H11621

NOAA FORM 76-35A	
U.S. DEPARTMENT OF COMMERCE NATIONAL OCEANIC AND ATMOSPHERIC ADMINISTRATION NATIONAL OCEAN SURVEY	
DESCRIPTIVE REPORT	
Type of Survey	Hydrographic
Registry No.	H11621
LOCALITY	
State	Alabama
General Locality	Mississippi Sound
Sub-locality	Grand Bay to Petit Bois Pass
2006	
CHIEF OF PARTY Dean Moyles FUGRO PELAGOS, Inc	
DATE	LIBRARY & ARCHIVES

<p>REMARKS: The purpose of this work is to provide NOAA with modern debris mapping survey in the area of Mississippi Sound from Grand Bay to Petit Bois Pass.</p> <p>ALL TIMES ARE RECORDED IN UTC.</p> <p><i>Remarks in red, bold italics were made during AHB processing of this survey.</i></p> <p>FUGRO PELAGOS INC 3738 RUFFIN ROAD SAN DIEGO, CA 92123</p>

Figure 1.8.1

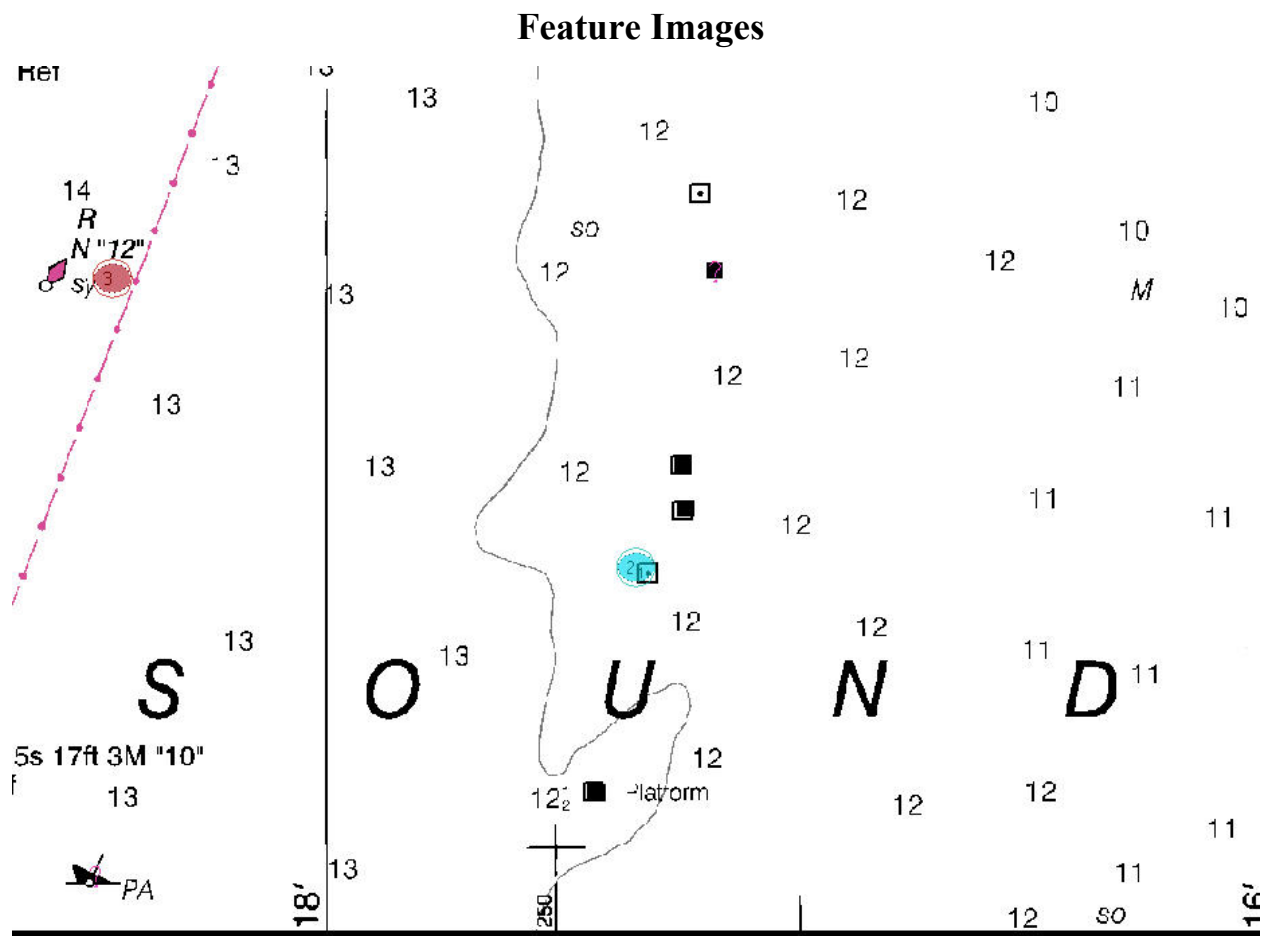
Recommend charting 7ft obstruction reported 2006. *Concur. Add a dangerous submerged obstruction symbol and the notation 7 ft rep 2006*

*Figure 1.9.1*

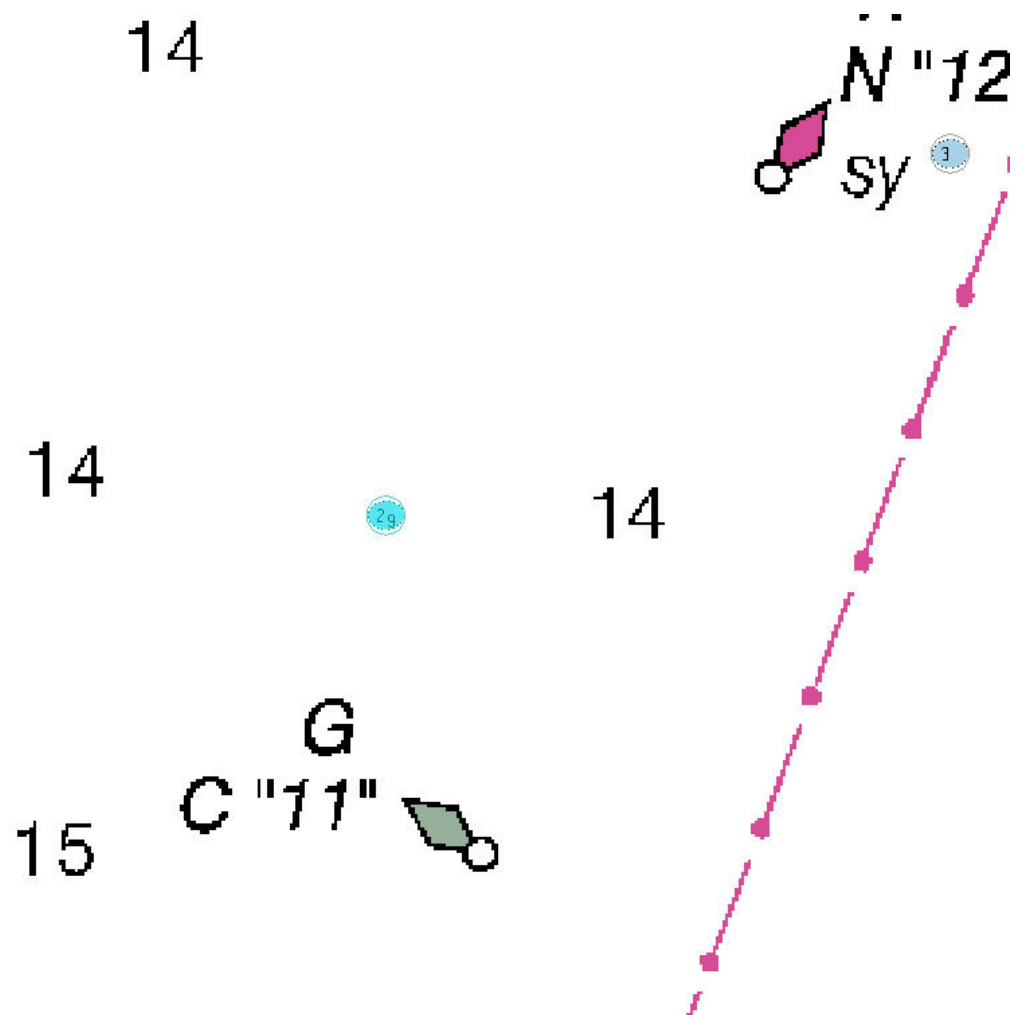
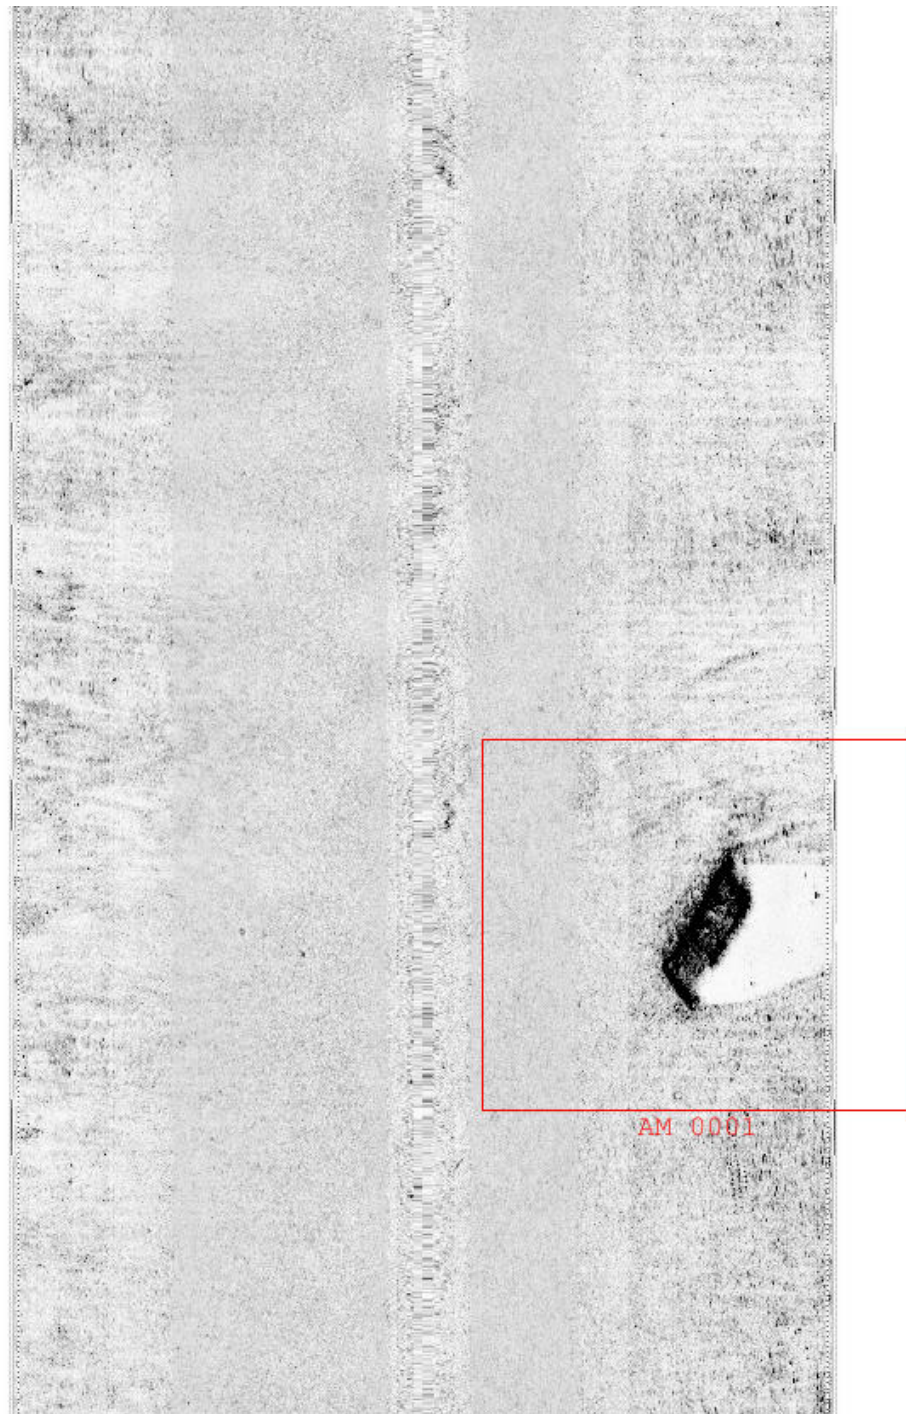
Recommend charting 9ft obstruction reported 2006. *Concur. Add a dangerous submerged obstruction symbol and the notation 9 ft rep 2006.*

*Figure 1.10.1**Figure 1.10.2*

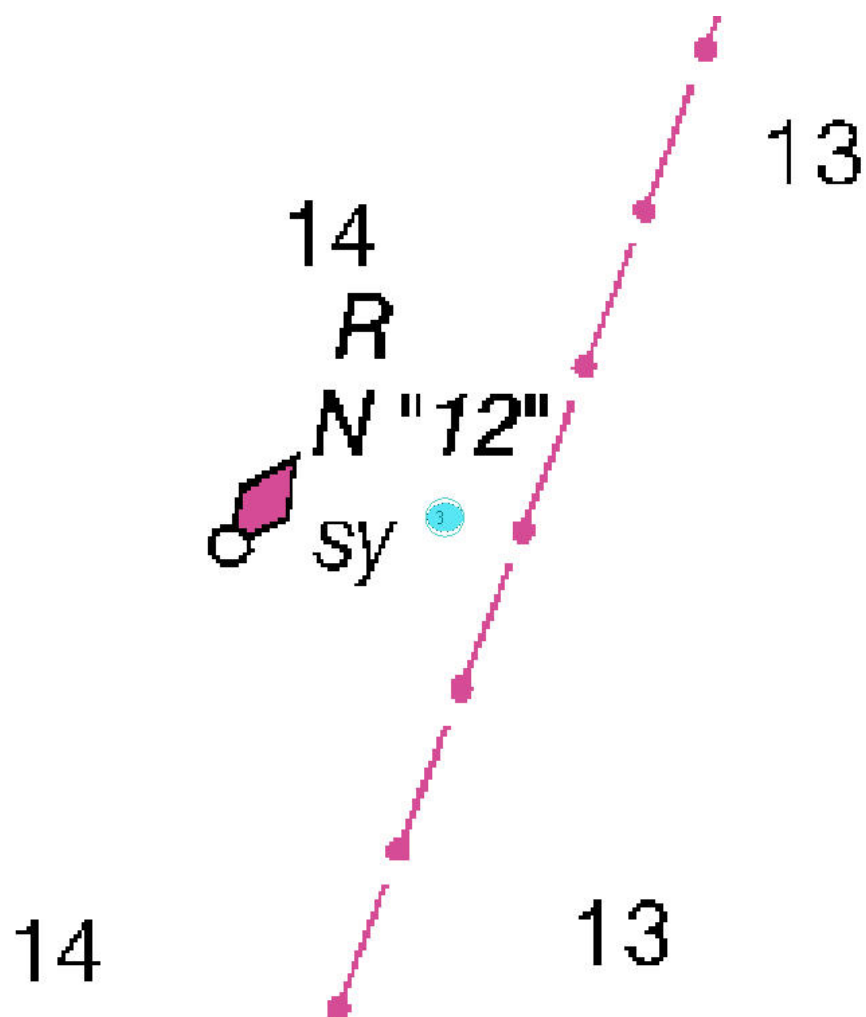
Recommend charting 10ft obstruction reported 2006. *Concur. Add a dangerous submerged obstruction symbol and the notation 10 ft rep 2006*

7ft (11374_2, 11373_1)

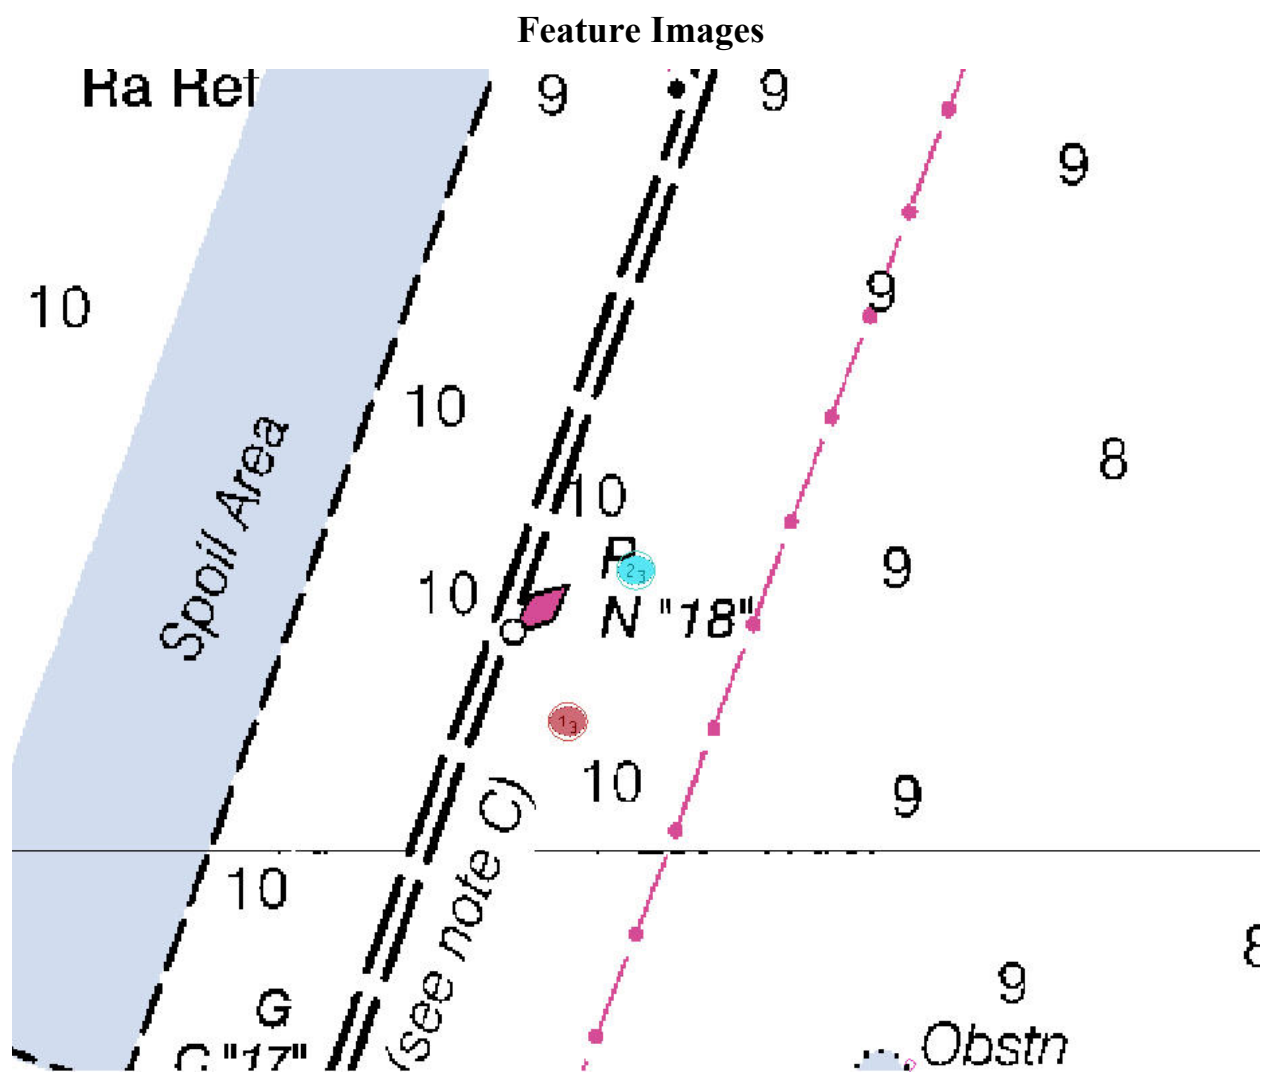
Recommend charting 7ft obstruction reported 2006. *Concur. Add a dangerous submerged obstruction symbol and the notation 7 ft rep 2006.*

Figure 1.16.1

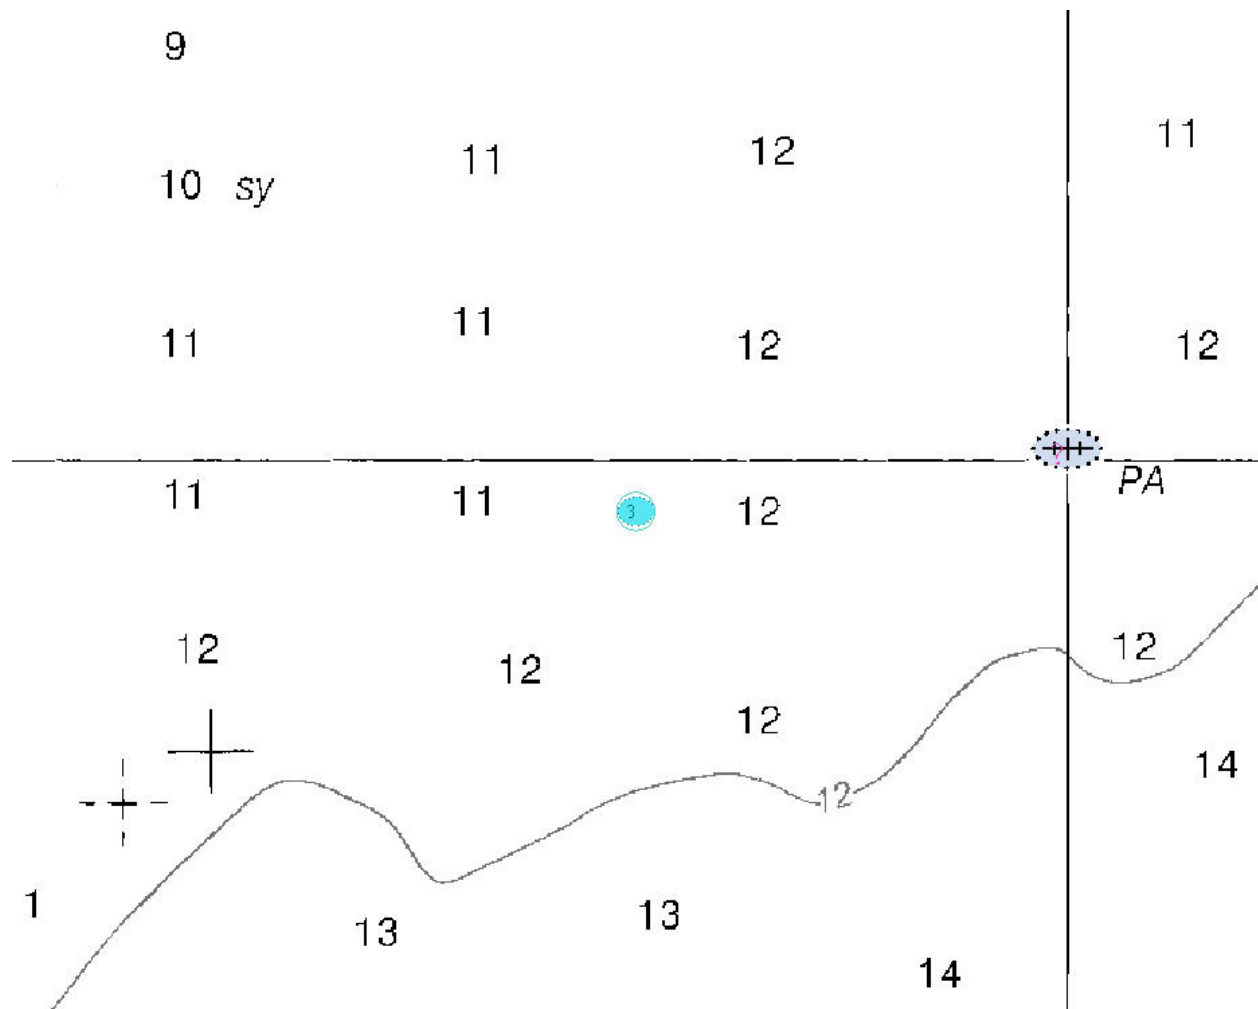
Recommend charting 10ft obstruction reported 2006. *Concur. Add a dangerous submerged obstruction symbol and the notation 10 ft rep 2006.*

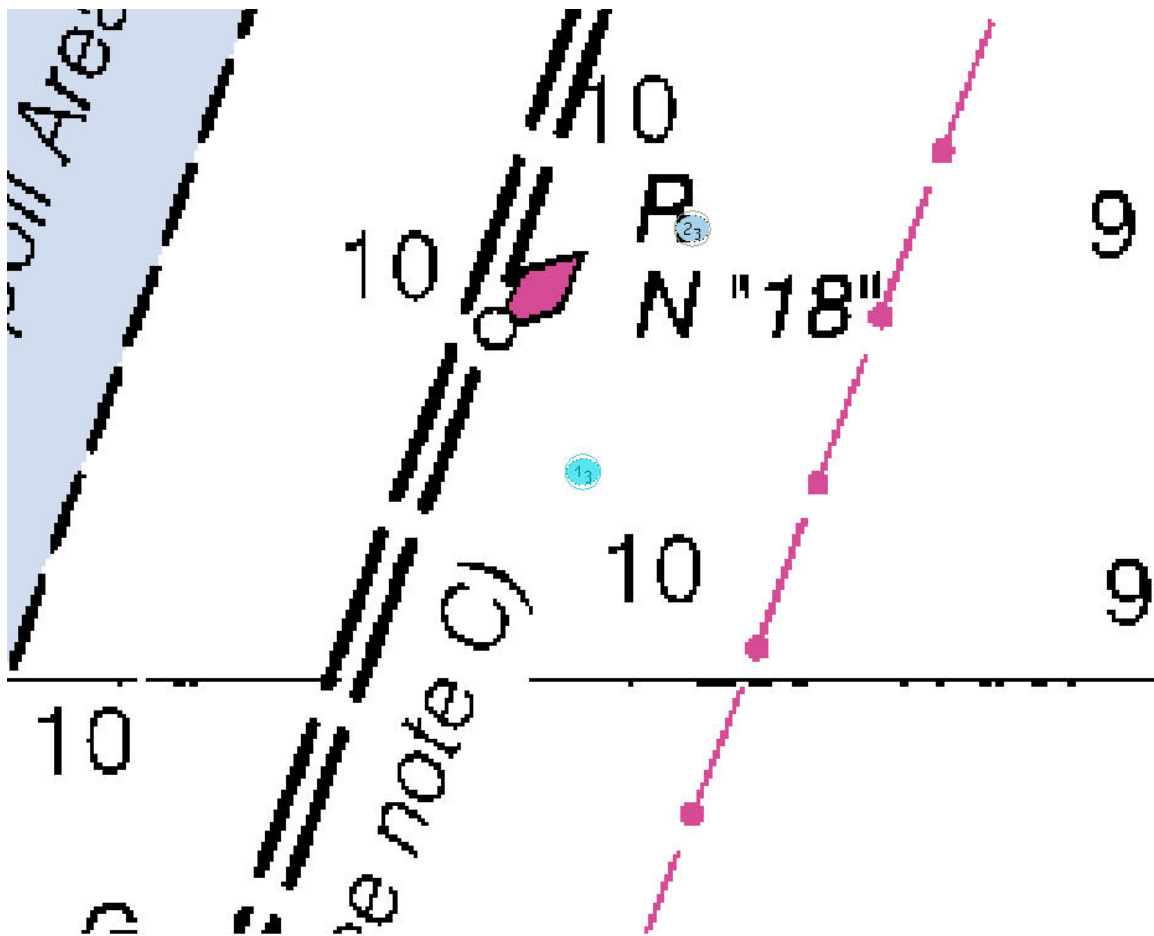
There were four obstructions identified during office processing of survey H11621 that appear to be uncharted exposed pipes. Feature 45-3 was submitted as a DToN while the other three were not. It is recommended that the owners of the pipes be contacted as there is potential that three could be leaking gas. Below are the images of the exposed pipes.

Feature 45-3 located at 30.33523750 N (***30° 20' 06.86"N***) 88.28939427 W (***88° 17' 21.82"N***) was submitted as a DToN to MCD.

Feature 39-2 located at 30.29198513 N(**30° 17' 31.15"N**) 88.31775217 W (**88° 19' 03.91"N**) was not submitted as a DToN. It appears to be an exposed pipe and the owner should be notified.

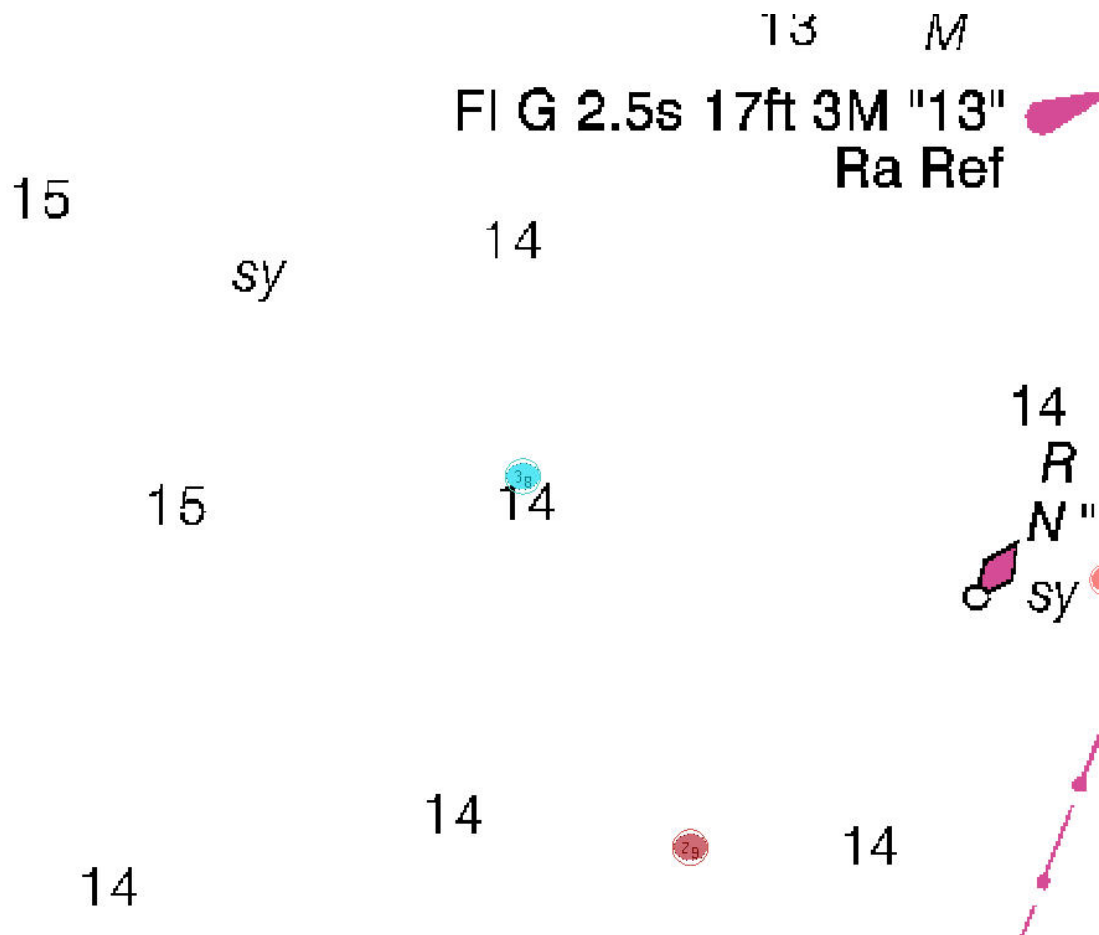
Figure 41-3 located at 30.31306333 N **30° 18' 47.03"N** 88.27528920W **88° 16' 31.04"N** appears to be a gas leak in the SSS. It is difficult to believe that the images are a real feature, rather are the result of the sonar being deflected by a gas plume in the water.
